CITY OF NEWTON, MASSACHUSETTS

SUBJECT: **Supplemental Memo**
Petition #102-06(2) KESSELER DEVELOPMENT, LLC petition for a **CHANGE OF ZONE** from **SINGLE RESIDENCE 3** to **MULTI RESIDENCE 3** for a parcel of land located on LaGrange Street, Ward 8, identified as Section 82, Block 37, Lot 95, and shown as **Lot H-1** on a Subdivision Plan of Land in Newton MA, "Toomey-Munson & Associates, Inc.," dated April 28, 2004, recorded with the Middlesex South County Registry of Deeds in Plan Book 2005, page 102.

Petition #102-06(3) KESSELER DEVELOPMENT LLC petition for a **SPECIAL PERMIT/SITE PLAN APPROVAL** to construct a condominium complex consisting of three (3) structures with one (1) multi-family residence of 52 dwelling units and two (2) single-family attached dwelling structures with a total of 10 units for a combined total of 62 dwelling units with accessory parking on land located on LaGRANGE STREET, Ward 8, known as Section 82, Block 37, Lot 95, and shown as **Lot H-1** on a Subdivision Plan of Land in Newton MA, "Toomey-Munson & Associates, Inc.," dated April 28, 2004, recorded with the Middlesex South County Registry of Deeds in Plan Book 2005, page 102, containing approxima

Kesse er Woods Site Planning Study

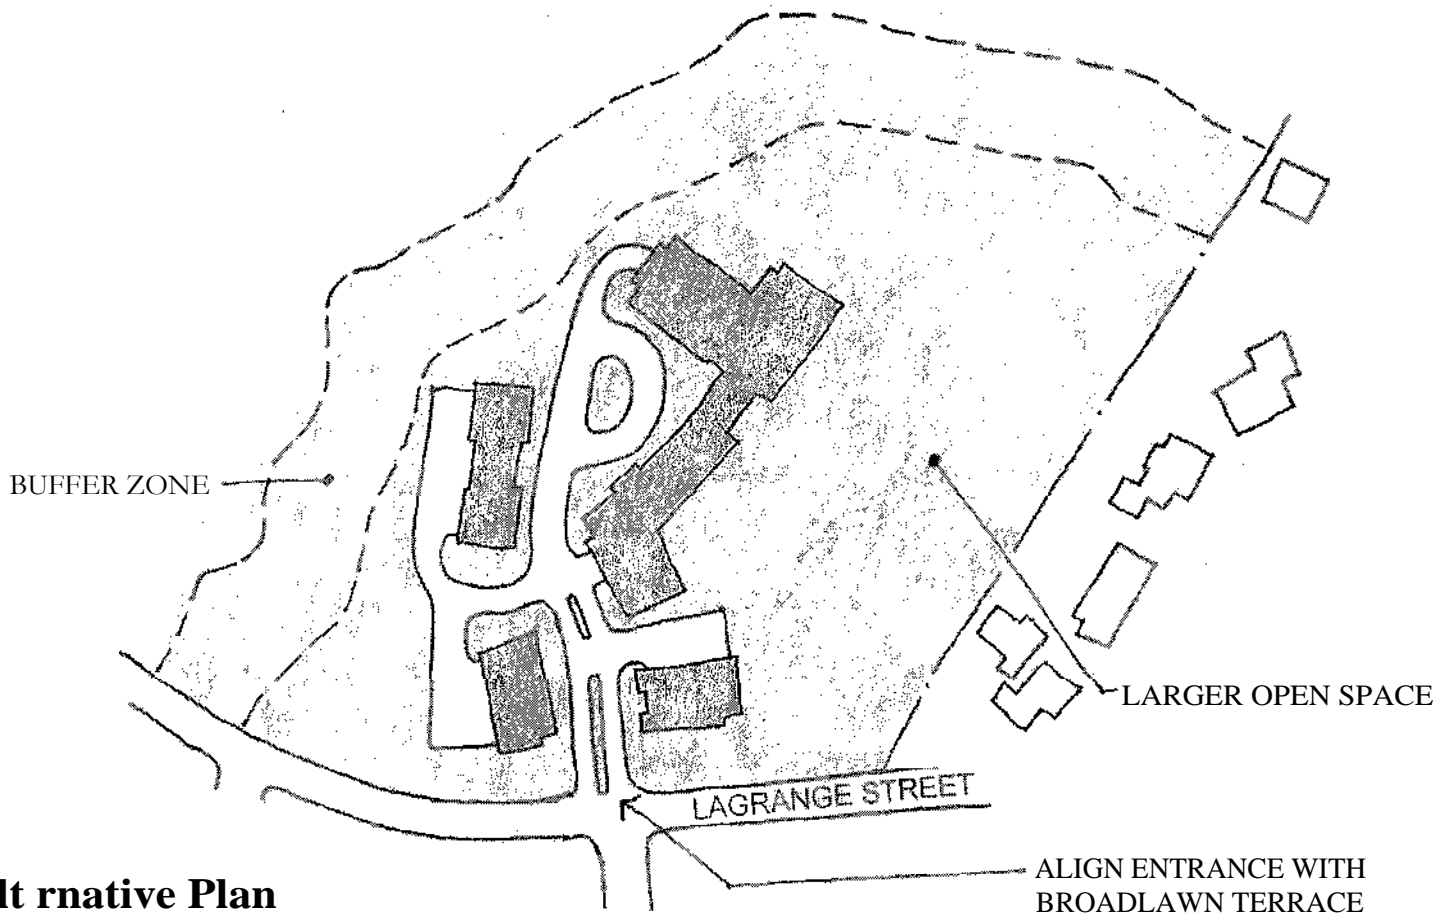
While the current proposal consumes less land than the earlier "preferred" plan, it could be improved further. As currently designed, it excessively impacts neighbors on Rangely Road. Of particular concern is the loop road design which results in an excessive amount of impervious area. An alternative strategy could include a smaller footprint that is located closer to Lagrange Street. This may result in the preservation of a larger portion of the existing knoll, while allowing a more substantial for the abutting single family residences. To illustrate this concept, we have prepared a conceptual design sketch for your review (please see attached).
